DEVELOPMENT ASSESSMENT REPORT
Shire of Augusta Margaret River
4 August to 10 August 2022

DEVELOPMENT APPLICATION ASSESSMENT
Report to Manager Planning and Development Services

Proposed Mixed Use Development - Offices x 6 & Upper Floor Apartment at 4 Bayview Drive, Gracetown.

Proposed Single House (Carport and Gym)
33 (Lot 32) Riedle Drive Gnarabup

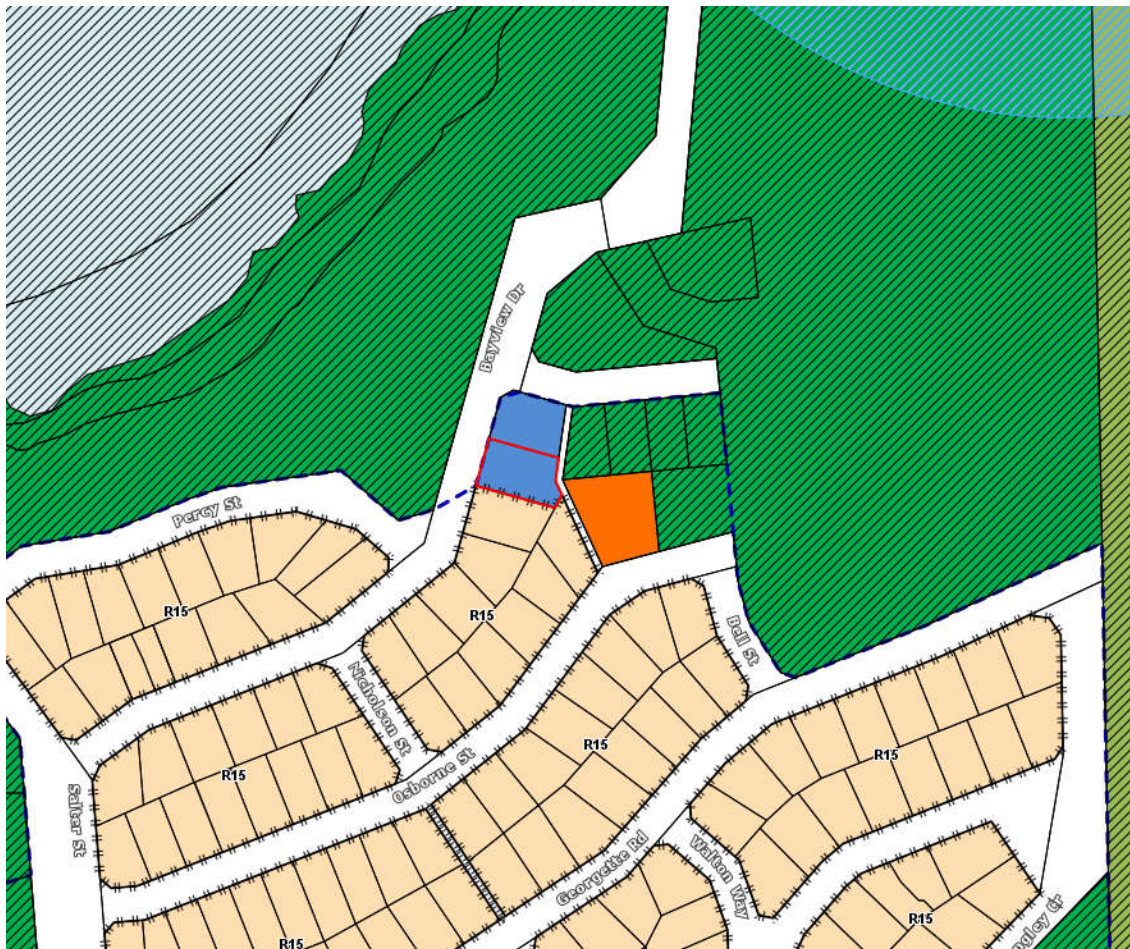
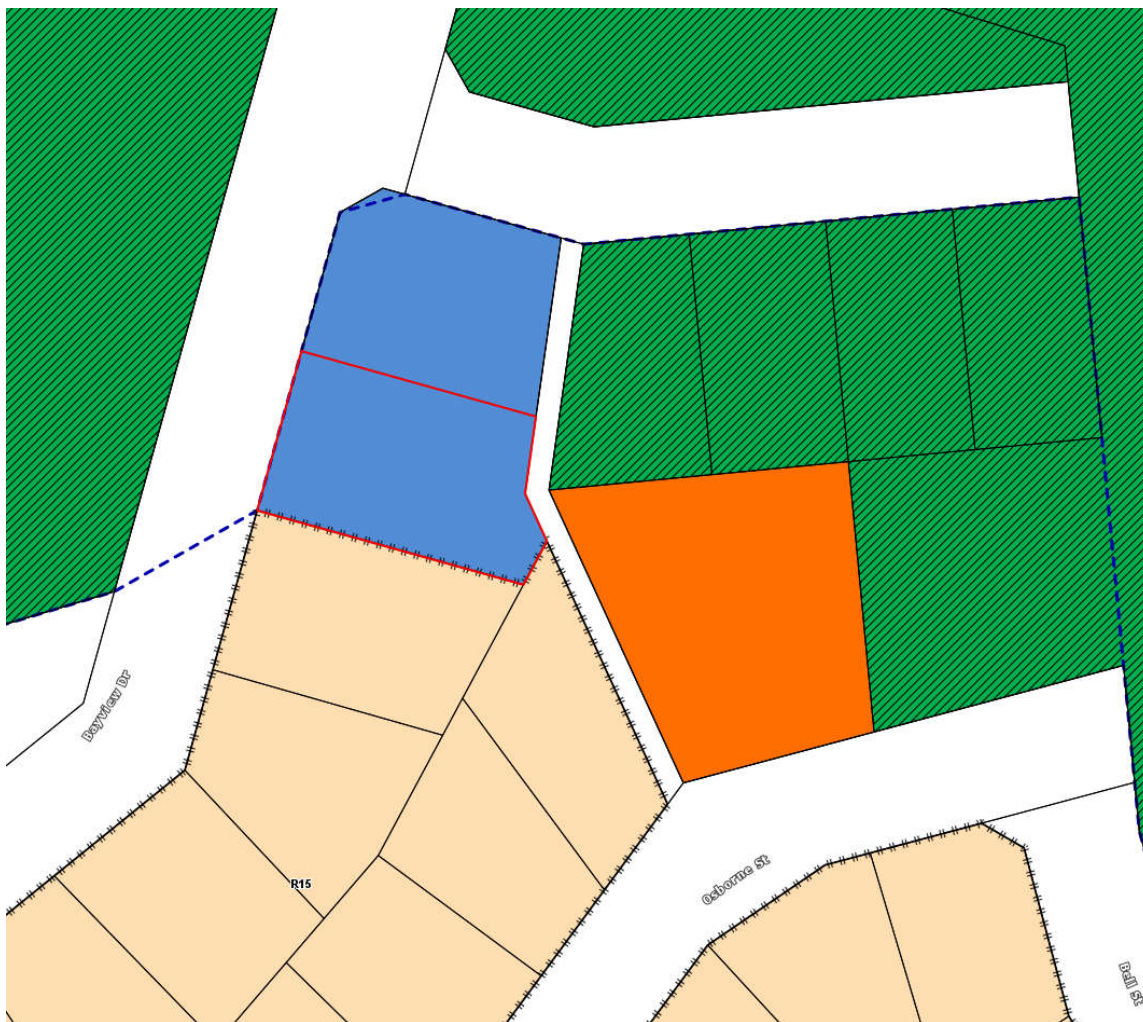
No. received: 2
Details of Submission	Officer Comment
<p>The proposal looks sound, however I have concerns about the height limit with the raised roof lantern over the kitchen of the apartment. The concerns over the roof lantern are held around the loss of visual amenity. We currently have views over north point across the boat ramp and onto the beach. With the addition of the roof lantern these views will be lost.</p> <p>The Shire should obtain an opinion from a licenced surveyor as well as viewing the original survey done by the original owner. A previous owner undertook additions to the roof height and parapet wall without approval. The roof and parapet wall now has a retrospective approval.</p>	<p>The neighbour comments were sent to the applicant who has subsequently amended the plans to reduce the overall size of the roof lantern by greater than 50%. The proposed height still presents a wall height variation, however the roof structure of the lantern is compliant with the 8m maximum height limit of LPS1.</p> <p>The proposed roof lantern has been reduced in footprint and contains glass windows to the walls. The reduction in footprint attempts to reduce the visual impact and assist in protecting sightlines from the neighbouring property to the south.</p> <p>The provided survey plan was undertaken in 2007 which incorporates any changes in NGL and roof levels. The supplied survey plan is assumed as being correct and matches what visually appears on the property.</p>

Officer Comment	<p>The proposed development is utilising the existing building envelope, with the addition of a cantilevered living room (to the western frontage), cantilevered master suite/ balcony (to the northern frontage) and a roof lantern above the proposed kitchen. The site slopes from the southern boundary to the northern boundary resulting in a sloping natural ground level. The existing parapet wall on the southern boundary is compliant with the 7m wall and 8m roof height.</p> <p>Cantilever Extensions:</p> <p>The proposed cantilevered master suite and living room are not proposing an additional wall or roof height than the existing building and only increase the total floor area. The cantilevered master bedroom proposes a maximum wall and roof height of 8.05m from NGL, at the north-western corner. The cantilevered living room proposes a maximum wall and roof height of 8m, at the north-western corner.</p> <p>The cantilevered sections are also being extended into the western (front) and the northern (side) boundaries of the lot. The master suite cantilevered extension faces north and is setback 9.6m from the neighbouring boundary. In addition, the neighbouring northern site sits considerably lower than the subject site and as such any potential visual impact is reduced. The proposed living room cantilevered section extends to the west of the site (street boundary) and is also on the north western corner of the development. The proposed location of the living room will not impact on the northern neighbour and reduces any potential impact on the southern neighbour by increasing the setback from the southern boundary. From the neighbouring southern property the cantilevered sections will not result in an additional building bulk in terms of height. View lines will remain the same as the existing building from the balcony and upper floor outdoor living area of the southern neighbour. It is also considered that the increase in floor area will not result in a negative visual impact from the neighbouring southern property due to the natural slope of the land.</p>

<p>Roof Lantern: The roof lantern above the kitchen within the apartment proposes a maximum height roof height of 7.8m and a maximum wall height of 7.7m. The proposed roof lantern proposes a variation of 0.7m to the prescribed maximum wall height in LPS1, the roof height is compliant with the maximum 8m. The roof lantern has been conservatively calculated as an extension of the internal wall and therefore required to meet the 7m maximum wall height limit. The walls of the roof lantern are however glass to enable light permeation, with only small structural aluminium frames. The glass construction will result in a reduction in potential building bulk and allow for view lines to the coast to be maintained. In addition, the applicant has amended the overall footprint of the roof lantern to reduce by over 50% in size, which was in response to neighbour concerns. The overall structure has been kept lightweight in materials and overall bulk to reduce the impact on the neighbouring property.</p> <p>Clause 5.13.1.12 of the Shire's LPS1 allow the height limits specified to be varied by not more than 20%, where certain criteria are met. Clause 5.13.2 allows for height variations to be considered where the local government is satisfied that the proposed building will be in harmony with the general character of buildings in the locality and will not adversely affect the beauty, character, quality of environment or the area generally. The proposed development is maintaining the existing roof height, with the addition of a roof lantern over the top of the kitchen. The proposed height variation is in response to the slope of the site and maintaining a consistent ceiling height within the existing roof line and the proposed additions. Despite a height variation the majority of the proposed height occurs on the northern side of the property which is setback from the boundary over 9m.</p> <p>The proposed height variation is not considered to have a major visual amenity impact and has been designed sensitively to reduce impacts where possible. The proposed height variation is supported and is capable of approval.</p>

The proposed parapet height is not being altered and the proposed roof will be rationalised to be a consistent height, aligned to the existing roof height.
<p>Concerns are raised in relation to the proposed development regarding the planned water storage capacity.</p> <p>A caveat currently allows the owner of the proposed development to draw water for a bore located on a neighbouring lot. At the time the caveat was established, there was only a restaurant on the subject site.</p> <p>The caveat is no longer considered fit for purpose for the following reasons:</p> <ol style="list-style-type: none"> 1. The caveat was drawn up to supply water to a restaurant. Since the caveat was drawn up an apartment has been built over the restaurant and a second three bedroom dwelling built at the rear of the lot. 2. The bore water is no longer potable due to the presence of Ecoli (water has been tested). 3. Over the years, the water table has dropped and the bore cannot supply sufficient water to both properties during the summer months. <p>The architect of the proposal has advised that a sufficient rainwater tank has been included in the proposal so as not to require any water from the bore.</p> <p>In summary, concerns are with the amount of water storage to be provided:</p> <ol style="list-style-type: none"> 1. For the proposed office tenancies and two dwellings. 2. For any possible future rezoning from commercial to residential. 	<p>The proposal includes two rainwater tanks, one existing and one new subsurface tank. The rainwater supply will be sufficient for the proposed development.</p> <p>The Shire is not party to the caveat and any administration/ changes to the caveat are required to be negotiated between the caveat parties (owners of both properties).</p> <p>It is understood that the application is intended to be self-sufficient through the implementation of the proposed rainwater storage.</p>

The following picture depicts the orientation of the objecting dwelling, which is away from the proposed development area.

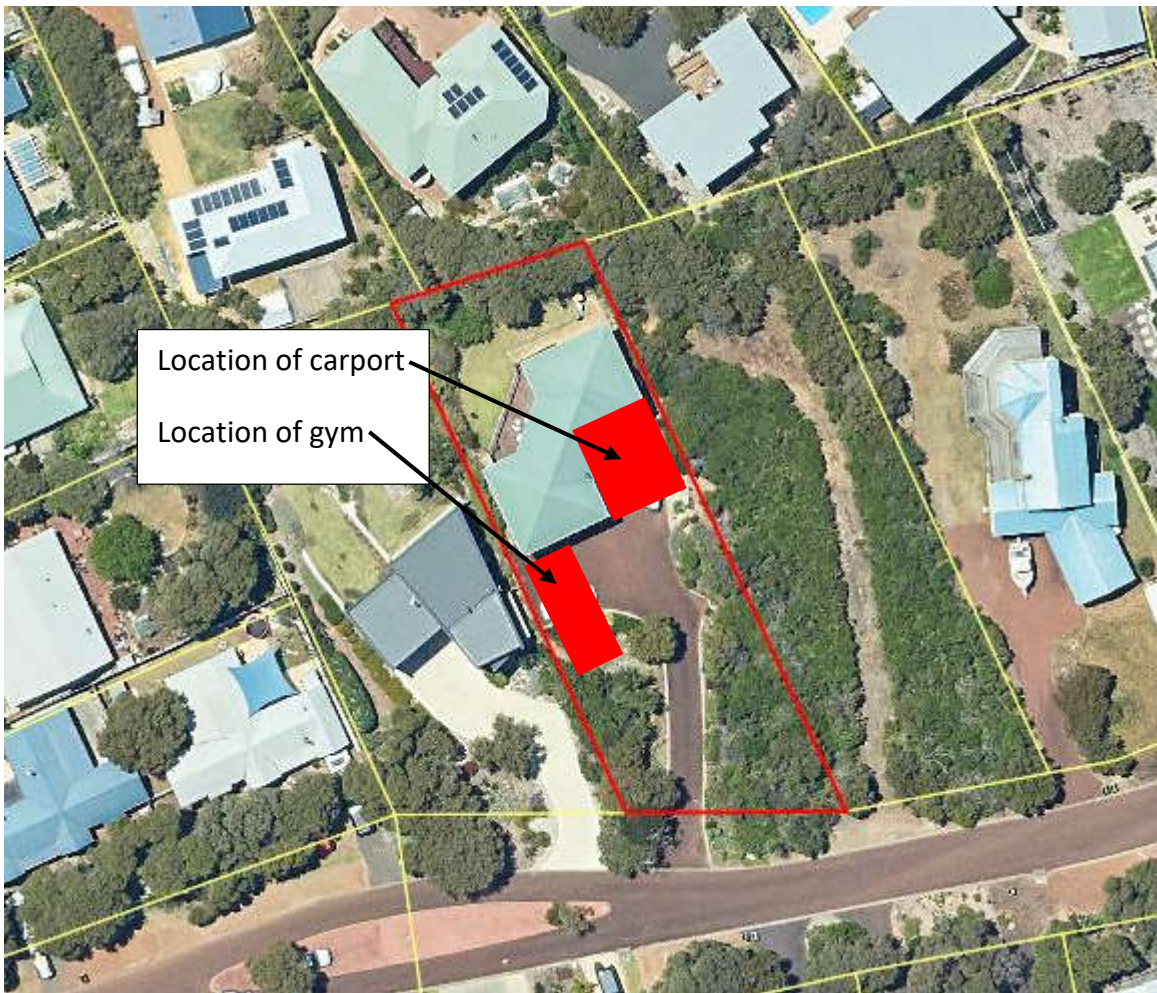
Details of Submission	Officer Comment
<p>Objection –</p> <p>Setback – the reduced setback will have an overbearing, crowding effect and significantly impact our sense of space. The development already has a significant retaining wall along the boundary and the impact of this being increased has an imposition to our property.</p> <p>There is no legitimate requirement for a domestic gym space of this size to be all on one level.</p> <p>Noise impact – The noise impact from the gym being so close to our property is a concern and possibly requires sound proofing or some sort of buffer zone. Lastly there needs to be assurance that the commercial business will not be carried on at the gym.</p>	<p>The comments of the neighbour are noted.</p> <p>The reduced setback of the retaining for the proposed gym has been addressed by the applicant as follows:</p> <p><i>The impact on the neighbouring dwelling is minimal given the existing walls on this elevation of their house are primarily blank with most views and living spaces focused on views and light to the north west as is appropriate for any dwelling on this site. This particular area of the site appears to service access to the house primarily, rather than living space.</i></p> <p><i>To keep the proposed gym at the same floor level as the existing residence ground floor level will provide greater amenity for the site, rather than stepping the structure down the block. This also means there will be less clearing of extant vegetation, as the existing retaining wall, and vehicular hardstand area can be utilised for the gym space.</i></p>

- The proposed addition is setback from the lot boundary to provide adequate ventilation and sun to the site and adjoining property.
- The side of the adjacent dwelling has no major openings facing onto the proposed development, with the main living areas facing north-west.
- There is no overlooking impact as a result of the proposed development.

<p><u>Operation of the gym:</u></p> <p>The proposal does not involve a home business component and therefore will not be permitted to be used for public use. This will be conditioned as part of the approval in order to enforce non-compliance should commercial use occur in the future without approval.</p> <p><u>Noise:</u></p> <p>Noise is subject to separate legislation (Noise Regulations) that the proposal is required to comply with. This will be included as an advice note on the proposal. Any future noise complaints will be dealt with by Environmental Health, should these arise as a result of the development.</p> <p>Despite the neighbour's objection to the proposal the impact of the proposed gym on the neighbouring site is minimal as addressed by the applicant. Conditions on approval will address the use of the proposed gym.</p>
--	--
